APPLICATION FOR MODIFICATION ASSESSMENT REPORT

Application Number:	Mod2021/0647
Responsible Officer:	Penny Wood
Land to be developed (Address):	Lot 101 DP 1110110, 96 - 97 North Steyne MANLY NSW 2095
Proposed Development:	Modification of Development Consent DA 272/2017 for Alterations and additions to an existing Residential Flat Building
Zoning:	Manly LEP2013 - Land zoned R3 Medium Density Residential
Development Permissible:	Yes
Existing Use Rights:	No
Consent Authority:	Northern Beaches Council
Delegation Level:	NBLPP
Land and Environment Court Action:	No
Owner:	Cecil George Koutsos Isabel Brenda Koutsos
Applicant:	Squillace Architects

Image 1: Roof plan indicating setbacks from mechanical plant screening to eastern, western, northern and southern boundaries.

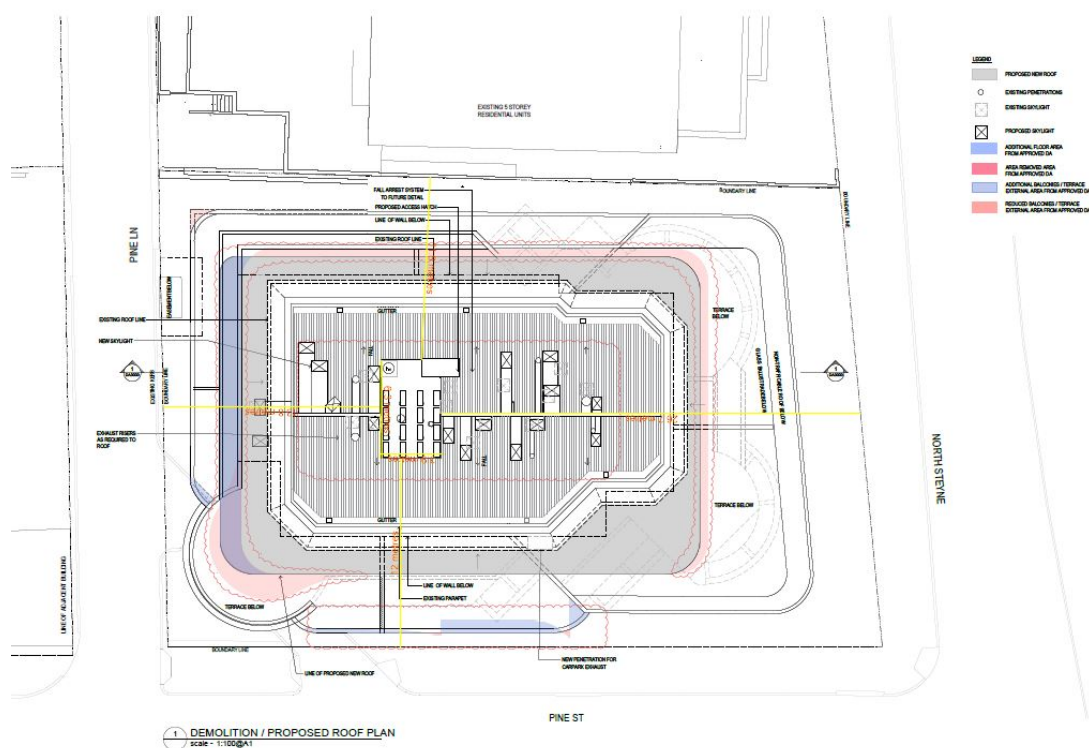
The application proposes mechanical plant with acoustic screening on the roof of the subject residential flat building. The mechanical plant and screening will measure a maximum height of 1.55m resulting in an overall building height of 16.45m (RL22.41). A condition is imposed in the consent to ensure that the highest point of the development does not exceed RL22.41 with the louvred screening in association with the mechanical plant will not measure greater than 1.55m above the approved top of roof (RL20.79). Whilst the plant and screening exceeds the maximum 13.0m height prescribed for the site, the mechanical plant and screening will not be visible from a public place, with generous setbacks to the eastern, western, southern and northern boundaries. The residential flat building currently measures 14.9m in height with the previous application (DA272/2017) approving amendments to the roof form.

The non-compliant mechanical plant and screening is confined to a central portion of the roof and is considered to have a minimal impact towards the amenity of the surrounding properties and the appearance of the building when viewed from a public space.

Comment: The proposed modification will increase the approved building height by 1.55m. The non-compliant mechanical plant with louvred screening maintain consistency with the topography and prevailing building height in the area. The proposed mechanical plant and screening will not be visible from North Steyne

- The mechanical plant louvred screening is limited to a maximum of 1.55m in height above the approved top of the roof (RL20.79) and is not to exceed an overall height greater than RL22.34.
- Delete the extension to the ground floor terrace for Unit 2 and Unit 3.
- Delete the proposed wall along the eastern boundary.
